# Planning Commission Agenda Report

February 14, 2018  
Item 6.a.

- SUBJECT:** P17-0278 and P17-0280
- APPLICANT:** BKF Engineers, Brock Roby
- PROPERTY OWNER:** Surf Thru, Inc., Scott Howry
- PURPOSE:** Applications for Design Review and Conditional Use Permit approvals to construct and operate a semi-automated car wash and related site improvements.
- LOCATIONS:** 3598 Stanley Boulevard
- GENERAL PLAN:** Retail, Highway, and Service Commercial; Business and Professional Offices
- ZONING:** PUD-C (Planned Unit Development – Commercial)
- EXHIBITS:**
- A. [Draft Planning Commission Resolution](#) with [Conditions of Approval](#)
  - B. [Project Plans dated "Received February 7, 2018"](#)
  - C. [Noise Assessment](#)
  - D. [Location and Notification Map](#)

Figure 1: Proposed Site Plan

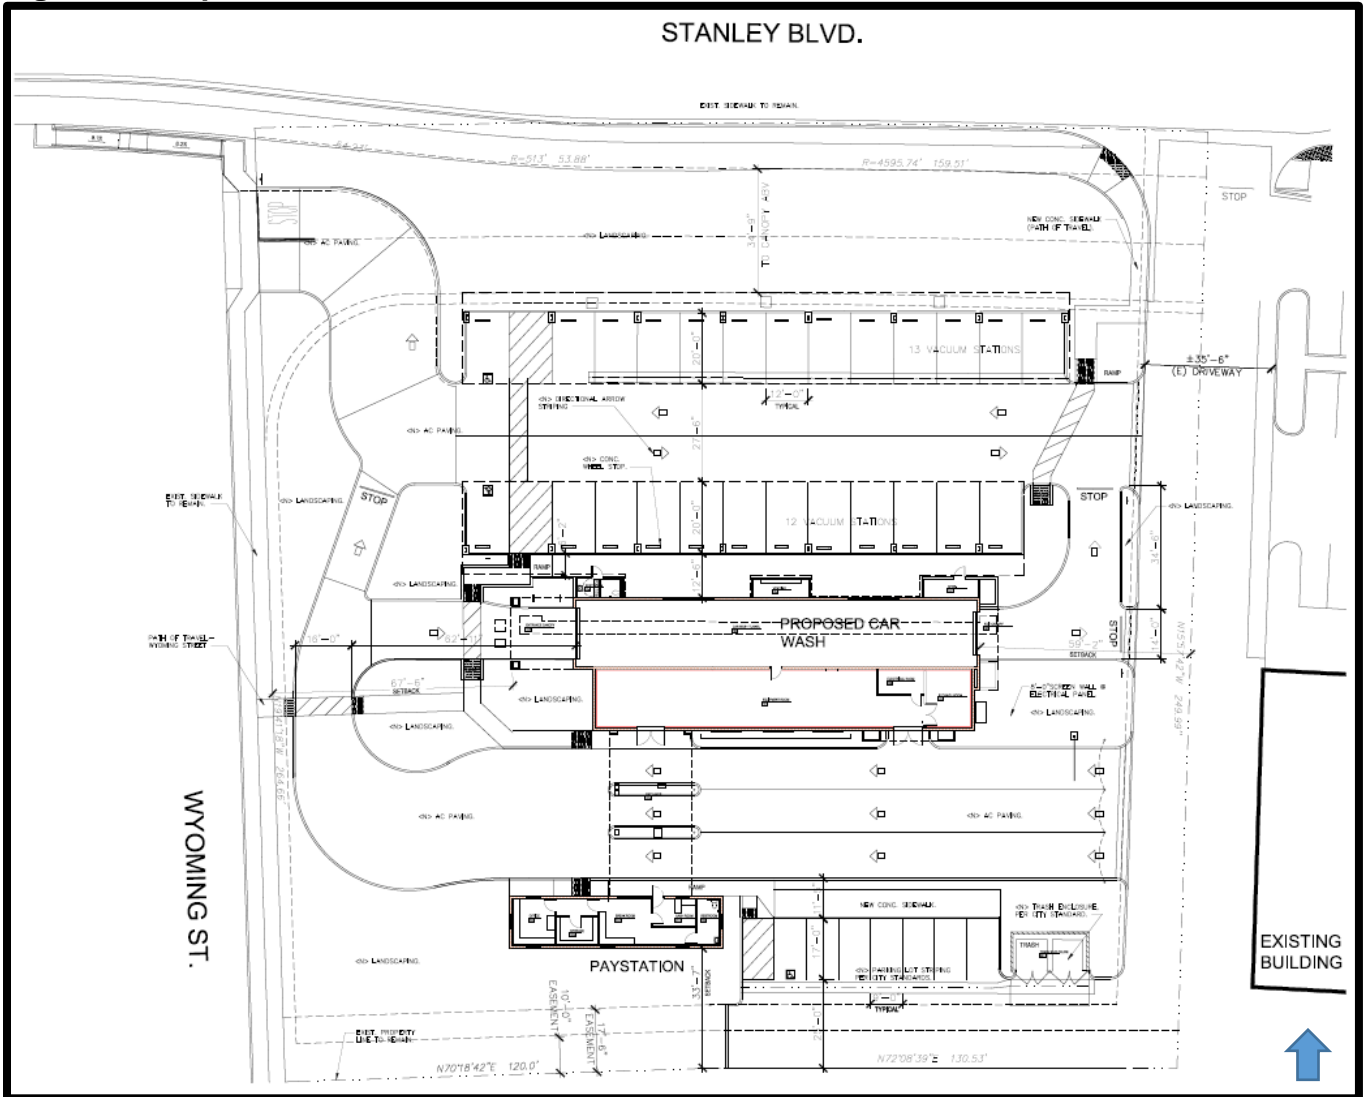
The proposed layout provides setbacks well in excess of those required, and the project complies with all of the other PUD and C-S zoning district development standards.

**Figure 2: Proposed North Elevation (Stanley Boulevard)**

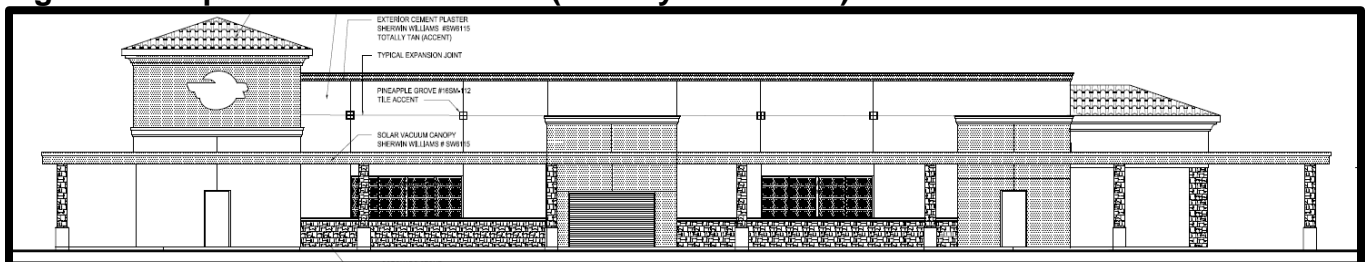
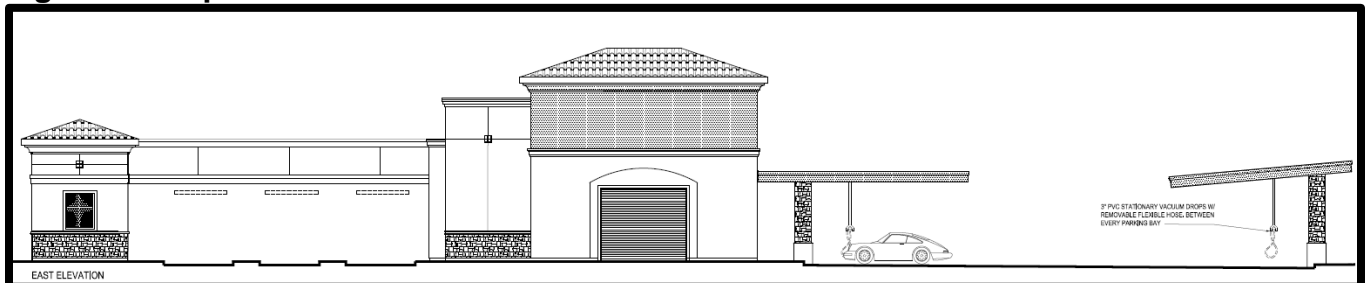
The car wash facility would be highly visible from Stanley Boulevard. Staff believes the use of stone and stucco, incorporation of windows and architectural features (score lines), earthtone colors, and landscape trellises breakup and offer variation in the wall planes. An eight-foot-tall screen wall is proposed around the electrical panel on the east side of the building. Staff does not typically support the use of tall walls to screen cabinets and equipment, such as the one proposed. Staff’s recommendation, as conditioned, is to paint the cabinet/electrical panel such that it matches the building and install landscaping around it to soften and screen the enclosure.

Please refer to Figures 2 and 3 and Image 4 for north and east elevations and Exhibit B for color elevation drawings. Staff believes the building is well designed, functional and attractive and finds the design appropriate and complementary to the buildings within Stanley Business Park.
